29 March 2022

**RE: MP06\_0183 MOD 2 - SECTION 75W MODIFICATION APPLICATION TO MODIFY CONCEPT PLAN  
MP06\_0183 - MIXED USE RESIDENTIAL/TOURIST DEVELOPMENT  
RESPONSE TO SUBMISSIONS  
147 SOLDIERS POINT ROAD, SOLDIERS POINT (LOT 31 DP 529002)**

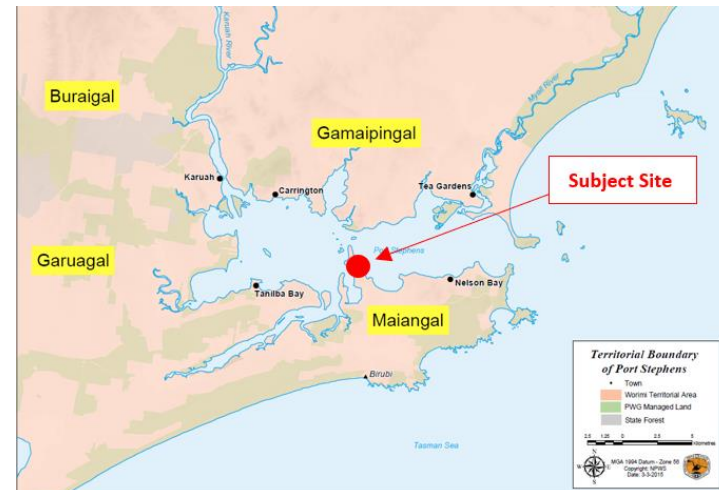
No.	Extract	Response
RFS1	<p>Given that the land is not mapped bush fire prone land, the NSW RFS advises that condition 13 of the NOD can be deleted and condition 12 Landscaping be amended to include:</p> <ul style="list-style-type: none"> <li>The entire site will be maintained as an inner protection area and landscaping within the site will comply with Appendix 4 of <i>'Planning for Bush Fire Protection 2019'</i>.</li> </ul>	<p>The recommendation from NSW RFS to remove condition 13 of the Notice of Determination (NOD) for Concept Approval MP06_018 and amend Condition 12 is noted. Although an APZ is no longer required due to the site's bushfire classification in accordance with s10.3 Environmental Planning &amp; Assessment Act (EP&amp;A Act) Bushfire Prone Area Mapping, BEMC has provided recommendations for bushfire mitigation measures in the Bushfire Addendum Letter held at <b>Appendix H</b>. These recommendations are as follows:</p> <ul style="list-style-type: none"> <li>The entire lot be a managed to Inner Protection Area Standards of an Asset Protection Zone.</li> <li>The existing water hydrant in the south-eastern corner be maintained.</li> <li>Vehicle access along the grass verge associated with Soldiers Point Road be provided to the existing water hydrant.</li> <li>A live fire hose connected to reticulated water mains, constructed in accordance with AS/NZS 1221:1997 Fire hose reels, and installed in accordance with AS 2441:2005 installation of fire hose reels is located in the south-eastern corner of the lot between the building and vegetation to the south.</li> <li>A clear pedestrian access path is provided between the existing water hydrant in the south-eastern and fire hose in the south-eastern corner.</li> </ul>

<ul style="list-style-type: none"> <li>• All glazing elements along the southern elevation of the proposed building be to BAL29 construction standards".</li> </ul> <p>In relation to Condition 12 of the NOD, it is noted the detailed Landscape Plan for the site will need to be in accordance with Appendix 4 of <i>'Planning for Bush Fire Protection 2019'</i> if this amendment to the condition proceeds.</p>
--	--	---
